Request for Class II Permissive Change(C2PC)

FCC ID: VG8XM136AXX

This is a C2PC application for which the previous grant was issued on 12/29/2011.

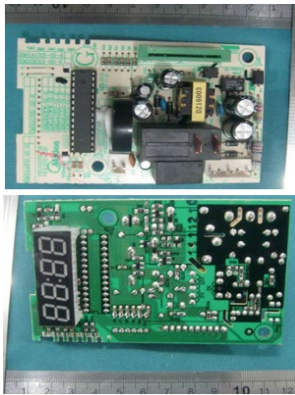
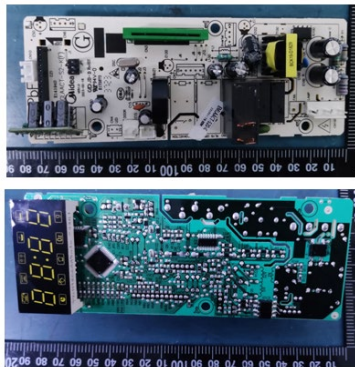
No.:	Original	New	Difference(s)
1			<p>Keypad: Updated front keypad to accommodate child lock function (Child resistant oven door function)</p>
2			<p>Mother board: Modified the peripheral circuit (non-RF circuit) and some individual components and PCB layout. The magnetron and other circuit are exactly same as before</p>
